SUBJECT: DONALD C. COOK NUCLEAR PLANT, UNITS 1 AND 2 - STAFF ASSESSMENT OF INFORMATION PROVIDED PURSUANT TO TITLE 10 OF THE *CODE OF FEDERAL REGULATIONS* PART 50, SECTION 50.54(f), SEISMIC HAZARD REEVALUATIONS FOR RECOMMENDATION 2.1 OF THE NEAR-TERM TASK FORCE REVIEW OF INSIGHTS FROM THE FUKUSHIMA DAI-ICHI ACCIDENT (TAC NOS. MF3873 AND MF3874)

STAFF ASSESSMENT BY THE OFFICE OF NUCLEAR REACTOR REGULATION

RELATED TO SEISMIC HAZARD AND SCREENING REPORT

DONALD C. COOK NUCLEAR PLANT, UNITS. 1 AND 2

Figure 3.3-1 Plot of the Staff's and Licensee's Base Case Shear-Wave Velocity Profiles. Shallow and Deep Refer to a Depth to Reference rock of 127 ft (39 m) and 3,387 ft (337 m) respectively for the DC Cook site

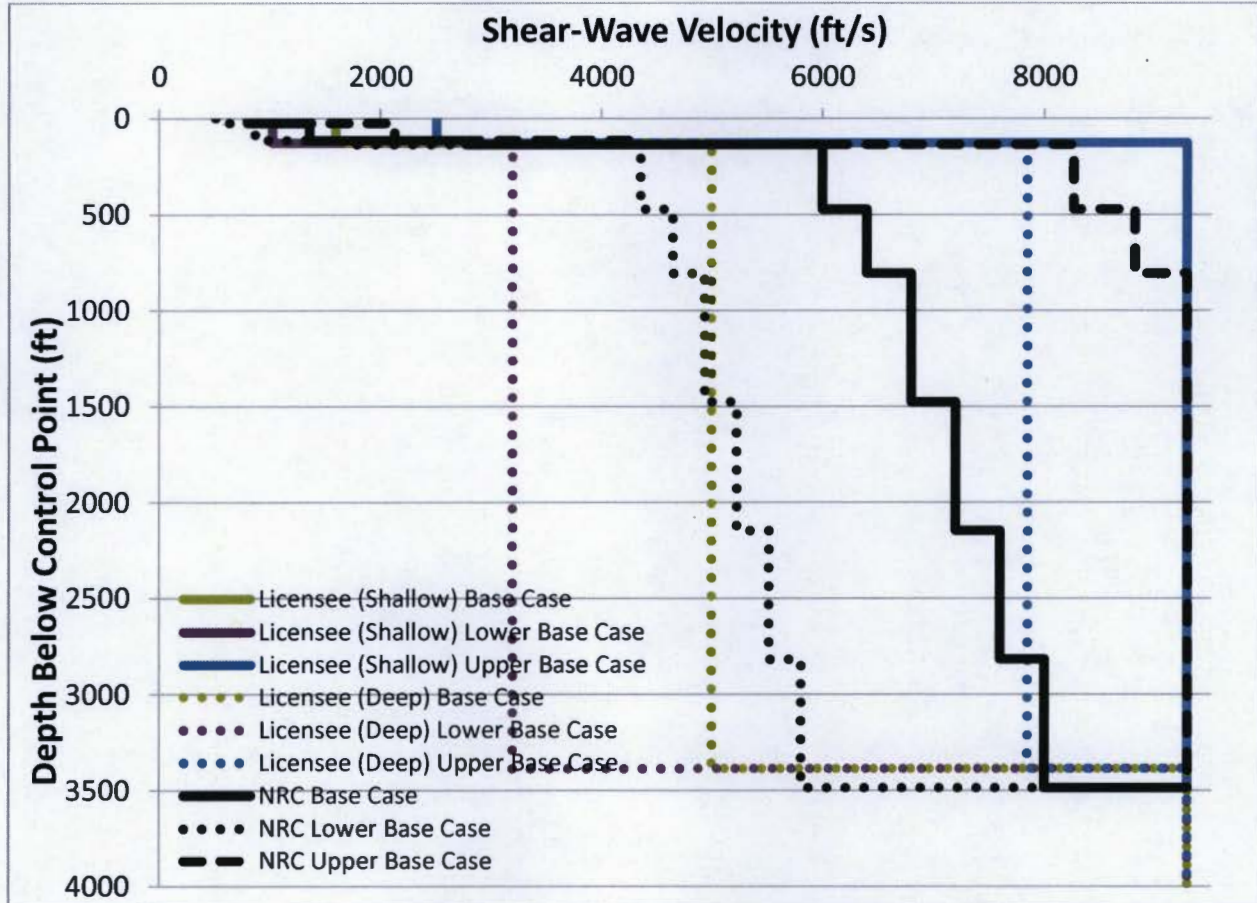
For all six base case profiles, the licensee inadvertently omitted the thin layer of beach sands in its velocity profiles. This omission resulted in total profile thicknesses of 127 ft (39 m) and 3,387 ft (1,032 m) instead of 161 ft (49 m) and 3,421 ft (1,043 m) for the shallow and deep base cases respectively. In its letter dated November 21, 2014 (Gebbie, 2014), the licensee committed to including the 34 ft (10 m) layer of beach sands in future risk evaluation activities.

In following the guidance provided in the SPID for sites with less subsurface information, the staff independently determined best-estimate and upper and lower base case shear-wave velocity profiles. The staff based its best-estimate velocity profile on information provided in the D.C. Cook UFSAR and guidance provided in the SPID. The staff modeled the upper 137 ft (42 m) of the profile as beach sand and lake deposits, and the sedimentary rocks underlying the surface soils assuming that the uppermost portions had a best-estimate shear-wave velocity of 6,000 ft/s (1,829 m/s) with a velocity gradient of 0.6 ft/s/ft. The staff used a natural log standard deviation of 0.35 to calculate upper and lower base case velocity profiles in the soil layers and a natural log standard deviation of 0.25 to calculate upper and lower base case velocity profiles in the rock layers. Figure 3.3-1 of this assessment shows a comparison of the six velocity profiles developed by the licensee with the three developed by the staff. The profiles developed by the licensee are more heavily weighted towards higher velocities because three profiles have shallower depths to reference rock. In contrast, all of the staff's profiles have reference rock at greater depth. The velocity profiles developed by the staff are somewhat higher than the second set of profiles developed by the licensee with reference rock at the base of the sedimentary rock section. The staff randomized the depth to reference rock by ± 10 percent to allow for additional uncertainty.

Figure 3.3-1 Plot Comparing the Staff's and the License's Median Amplification Functions and Uncertainties.

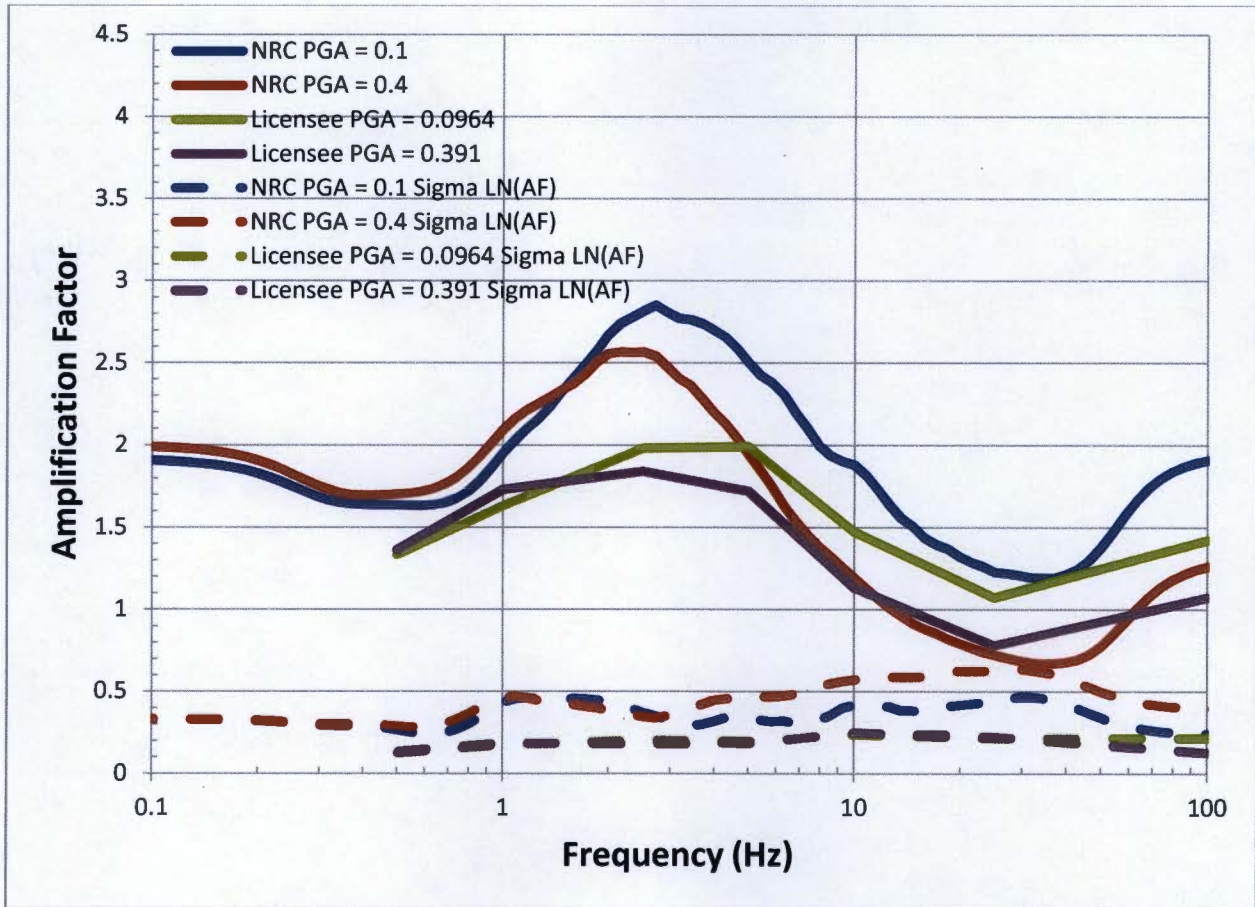
Figure 3.3-2 of this assessment shows a comparison of the staff's and licensee's median site amplification function and uncertainties (± 1 standard deviation) for two of the eleven input loading levels. Peaks in amplification functions occur between 3 Hz and 9 Hz in both staff and licensee curves. Differences in the amplification functions developed by the staff and licensee are due to the licensee's use of six profiles, as described above, with three of the six profiles having reference rock directly beneath the soil layers.

Figure 3.3-2 Plot Comparing the Staff's and the Licensee's Mean Control Point Hazard Curves at a Variety of Frequencies for the DC Cook site

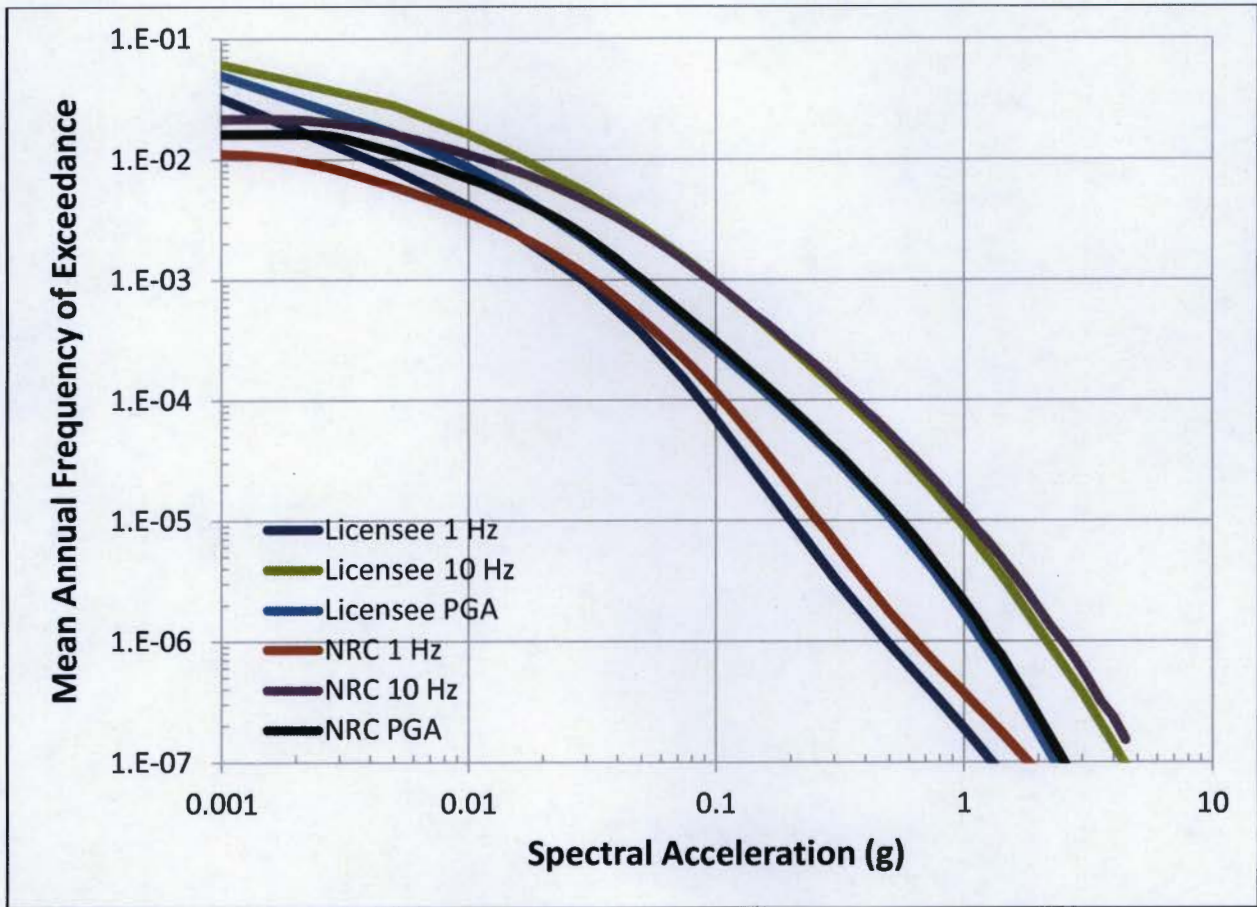
The licensee's approach to modeling the subsurface rock properties and their uncertainty results in lower site amplification factors than those produced by the staff, particularly at high frequencies. As shown in Figure 3.3-3 of this assessment, these differences in site response analysis have a relatively minor impact on the control point seismic hazard curves and the resulting GMRS, discussed below. Appendix B of the SPID provides guidance for performing site response analyses, including capturing the uncertainty for sites with less subsurface data; however, the guidance is neither entirely prescriptive nor comprehensive. As such, various approaches in performing site response analyses, including the modeling of uncertainty, are acceptable for this application.

Figure 3.4-1 Comparison of the Staff's GMRS with Licensee's GMRS and the DC Cook Unit Nos. 1 and 2 SSE

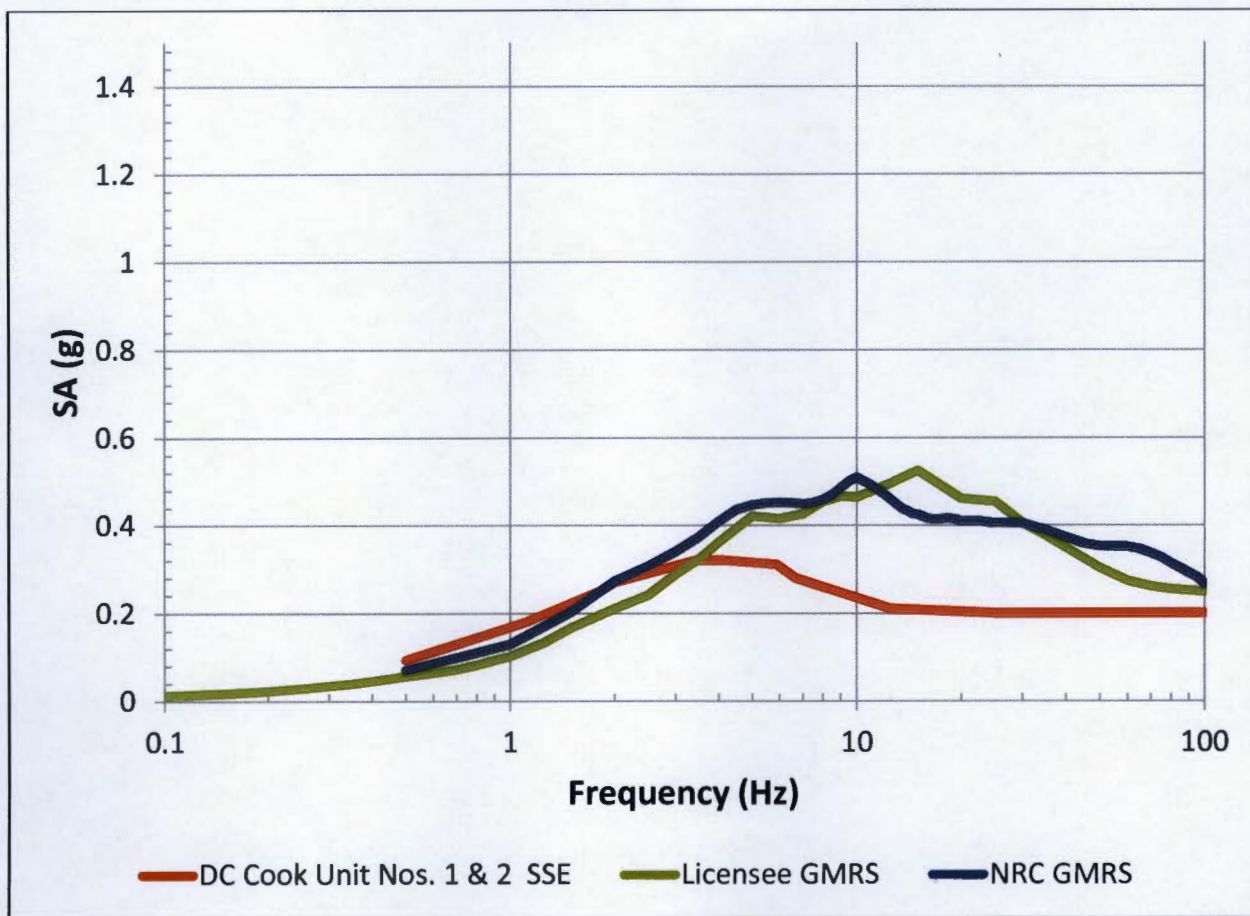
The staff independently calculated the 10^{-4} and 10^{-5} UHRS using the results of its confirmatory PSHA and site response analysis, as described in Sections 3.2 and 3.3 of this staff assessment, respectively. Figure 3.4-1 of this assessment shows a comparison of the GMRS determined by the licensee to that determined by the staff.

As shown in Figure 3.4-1 below, the licensee's GMRS shape is generally similar to that calculated by the staff with minor differences in the location and shape of spectral peaks in GMRS. These differences in GMRS are small and are the result of differences in the site response analyses performed by the licensee and staff discussed in Section 3.3 above. The staff concludes that these differences are acceptable for this application because the licensee followed the guidance provided in the SPID with respect to both the PSHA and site response analysis for the D.C. Cook site. The exception to this is the absence of the sand layer in the licensee's site response analysis, which the licensee has committed to including for future risk evaluation activities (Gebbie, 2014). Given that the sand layer was accounted for in the staff's site response confirmatory analysis and the results obtained were consistent to those obtained by the licensee, the staff does not expect any major changes between the hazard curves submitted for this application and the recalculated hazard curves expected to be used for future risk evaluations.

The staff confirms that the licensee used the present-day guidance and methodology outlined in RG 1.208 and the SPID to calculate the horizontal GMRS, as requested in the 50.54(f) letter. The staff performed both a PSHA and site response confirmatory analysis and achieved results consistent with the licensee's horizontal GMRS. As such, the staff concludes that the GMRS determined by the licensee adequately characterizes the reevaluated hazard for the D.C. Cook

site. Therefore, the GMRS with the sand layer accounted for, is suitable for use in subsequent evaluations and confirmations, as needed, for the response to the 50.54(f) letter.
